Consultation questions: response from Brian Copsey

Figure 1: PMSE Link Budget

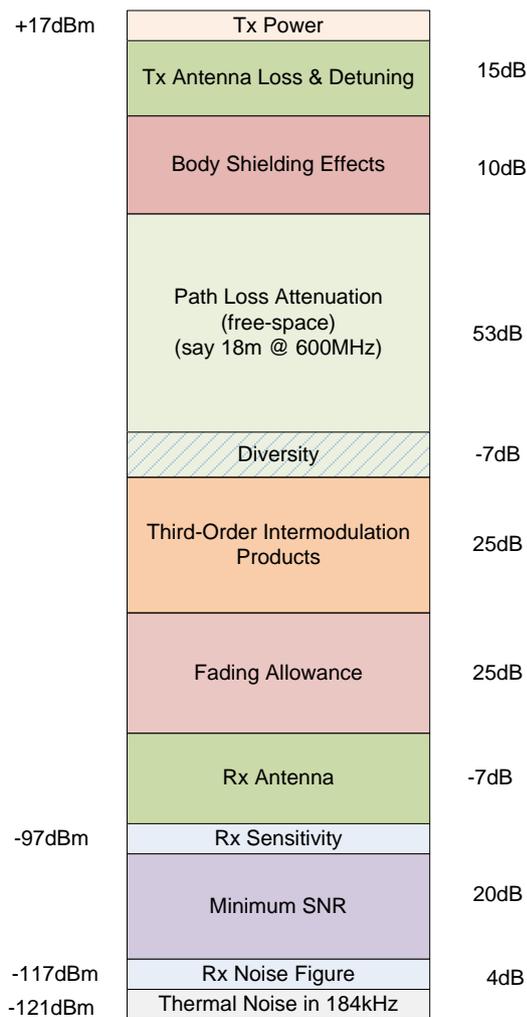
- From the Cambridge trial report the following link budget is shown below (similar to those within the CEPT Reports.

Figure 3 attempts to show a typical PMSE link budget, transmit power is limited by regulation (and acceptable battery life) to a maximum of 50mW (+17dBm) but is usually configurable to 1mW/10mW/50mW. From the figure above on the right we can see that a body-worn RM antenna gain of -15dB and a further estimated 10dB lost when the body shields the signal path in a real indoor environment.

We can assume a free-space loss over, some 22metres (at 600MHz) of 55dB and a further 30dB fading allowance due to multipath propagation which will be present for indoor locations and especially with stage props and lighting gantries etc. Using receive diversity can help reduce the needed fading allowance^[1]. Furthermore, the multichannel tests performed herein will show that a further 25dB can be attributed to the raised 'noise-floor' due to a sea of third-order intermodulation products in band.

The receive antennas are usually mounted at the rear of the auditorium close to the receivers and audio desk and are usually high gain and directional, hence an assumed gain of 7dBi.

Thermal noise in a 184kHz bandwidth is -121dBm, add to this an optimistic receiver noise-figure of 4dB we get a receiver noise floor of -117dBm. A 20dB SNR will

provide the minimum audio quality required from the system and so we arrive at the Rx sensitivity of -97dBm .

The figure of -97dBm was also reflected in the Ofcom testing and has not been challenged during the TWGs discussions. It therefore came as a an unwelcome surprise that Ofcom without any discussion with the PMSE industry or users dragged up a figure of -65dBm , developed at a very late night discussion for the Chester Conference some 16 years ago. The only conclusion that can be drawn is that the actual figure of -97dBm *does not supply sufficient spectrum for WSD in major conurbations and PMSE venues.*

Ofcom states that the -65dBm figure is supported in the Cambridge trial report, having been personally involved and checked with others involved in preparing this report I can only say: NO it does not support the -65dBm figure. Nor is it mentioned.

These appear to maximise WSD spectrum accessibility rather than PMSE protection. Please see answers to Q2 and the figure of at least -97dBm should be used
